Howard County
Health Department

FOR PERCOLATION TESTING AND SITE EVALUATION

RE: 15031 Bushy Park Road, Percolation Test Results, A530952 (and A530967)

WOODBINE, HOWARD COUNTY, MD 21797
LOT #7 "COUNTRY SPRINGS" LOTS 1-42
(A RESUBDIVISION OF LOTS 3&4, RIPPEON PROPERTY)
ZONING: R FLOOD ZONE: C ELECTION DIST: A
TAX MAP 14 PARCEL 12 PLAT #9648

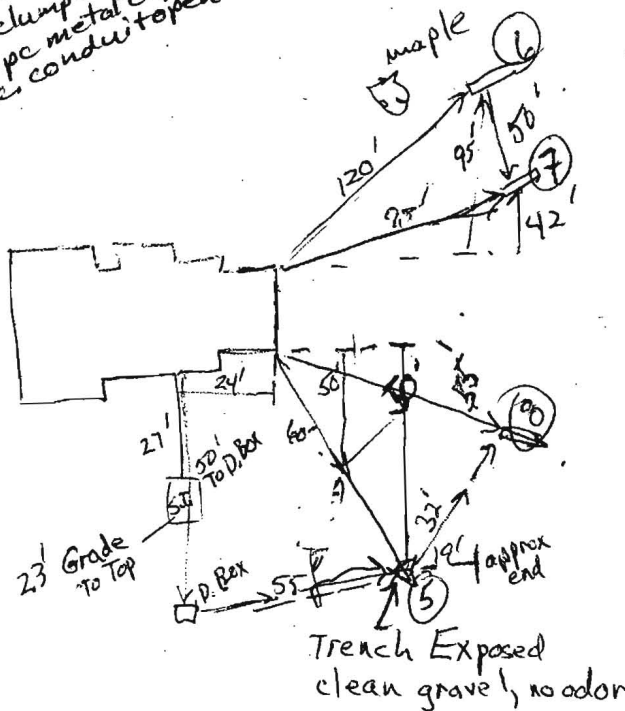
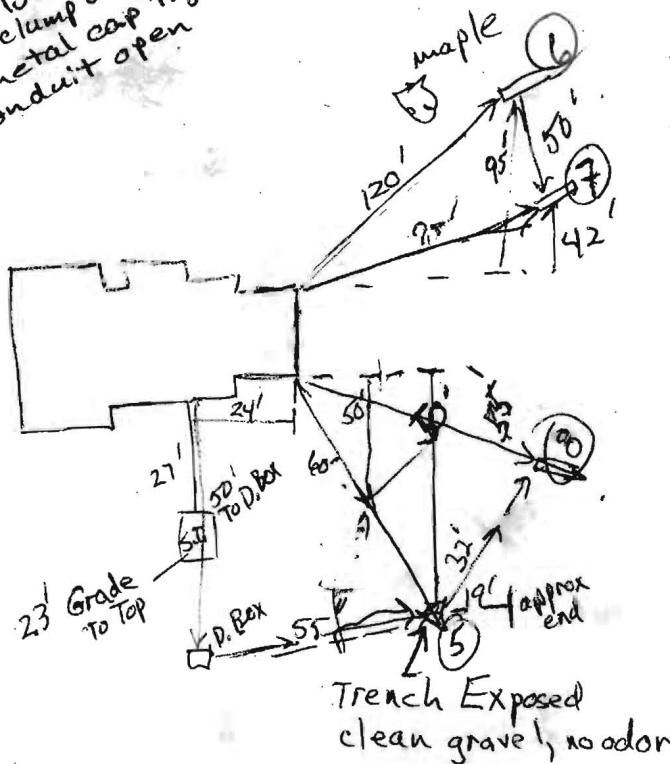
At the locations tested, the soil depth to seasonal water table was determined to be 11 feet. Locations #7 and #8 had moderately slow and moderate percolation rates, respectively. The primary limiting factor which occurred at test location #6 was very slow percolation rate throughout the soil profile.

REMARKS * Nov. 1988 perc describe ok to 13'; 3"-4" precip. last 5 days (5/2-5/6)
 moisture & weighty by 11' feet (5/7)
 sandy loam texture but more dense RB

Field data collected are shown on the Percolation Test Results Worksheets enclosed with this letter. Recommended Inlet and Trench Bottom depths, and Usable Sidewall are all based on observed soil properties and characteristics at respective test locations as well as the particular soils materials tested.

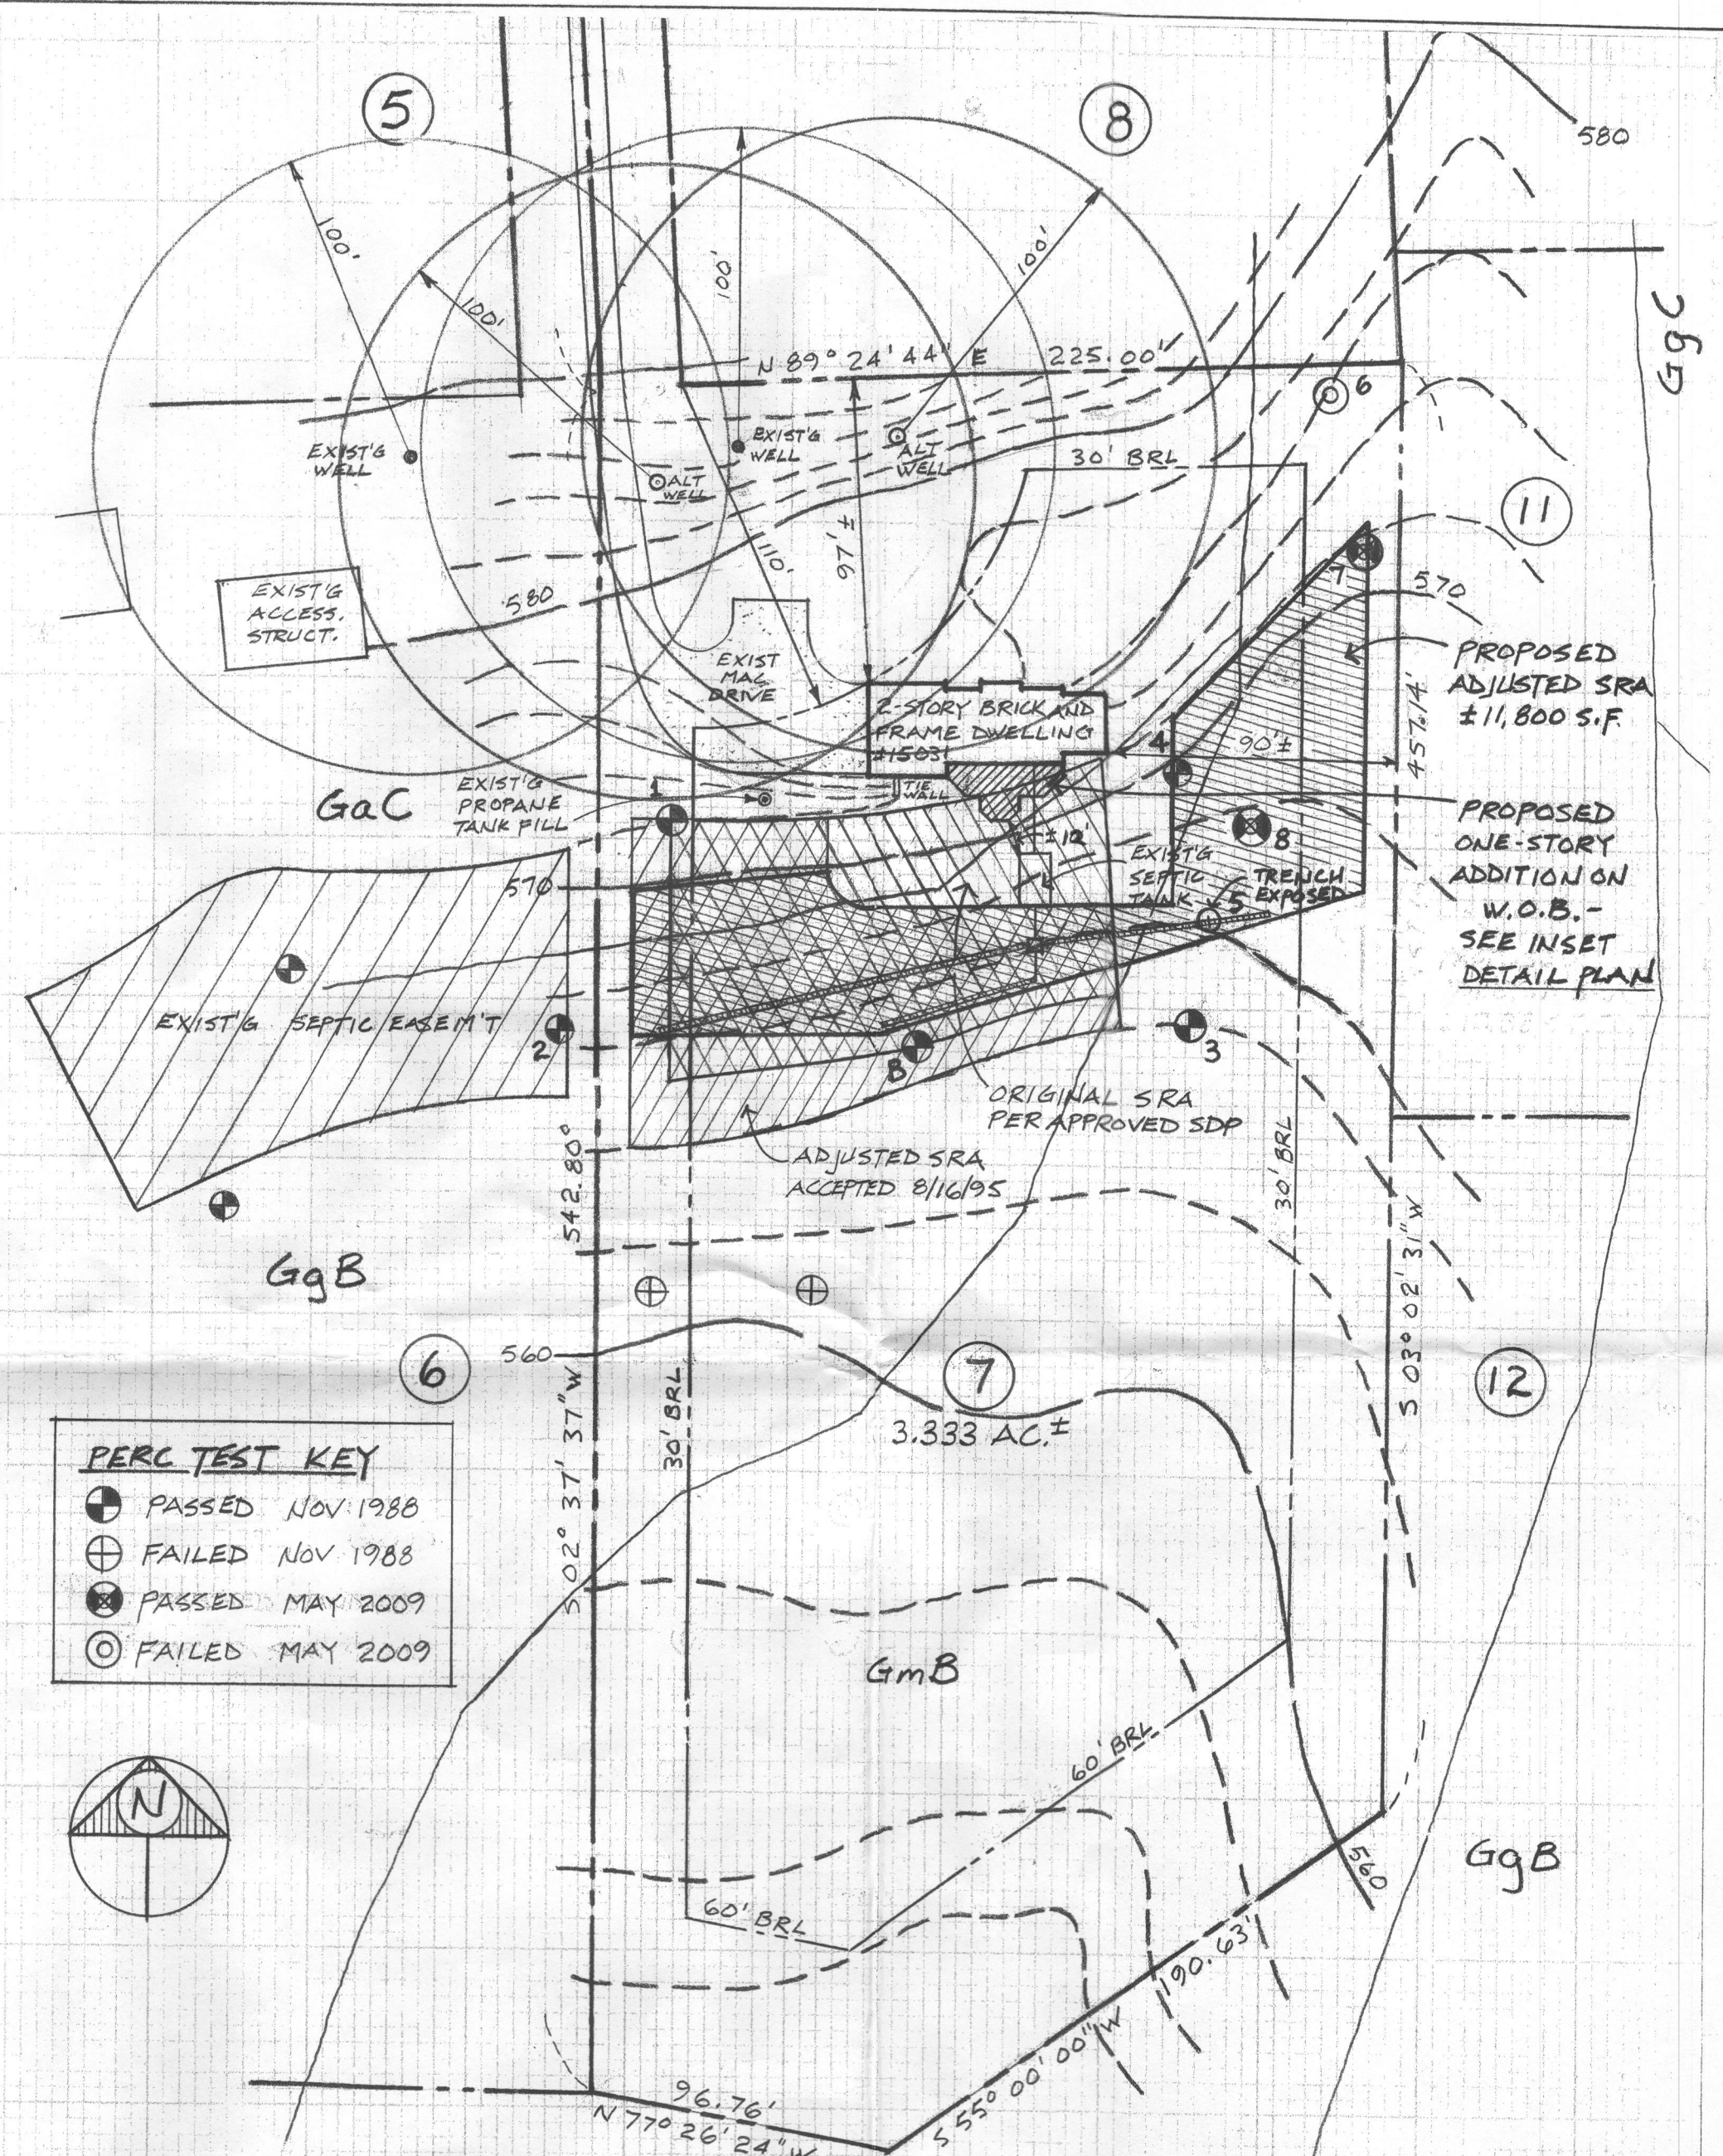
Area to be included in the revised septic easement is to include the current western portion of the easement, the top boundary being defined by regulated setbacks to LP tank, driveway, and structural foundation, and extending about 65 feet downhill to include the existing trench. The existing trenches are included in the revised easement. The area to be added angles from the existing trench to the (east) property line setback and then north to an approximate elevation contour common with the midway point between Failing test location #6 and Passing test location #7. The boundary of the easement would follow this contour to the setback of 20 feet from the house foundation and then join with the previously defined septic easement boundary.

The existing septic tank is located 27 feet from the foundation wall. You may submit a Request for Variance from the required setback of 20 feet from foundation to septic tank (to remain as the planned addition will extend to within 20 feet of the septic tank wall). Additional septic tank capacity will not be required. As there is not an increase of wastewater volume, no additional trench length will be required.

THE PURPOSE OF THIS PERCOLATION CERTIFICATION REVISION IS TO ADJUST THE SEPTIC RESERVE AREA ON THE SUBJECT PROPERTY TO INCLUDE ONLY SUITABLE AREA, AND IS IN RESPONSE TO A BUILDING PERMIT APPLICATION (B09000679) FOR EXTENSION OF THE KITCHEN AND TO INCLUDE A BREAKFAST NOOK.
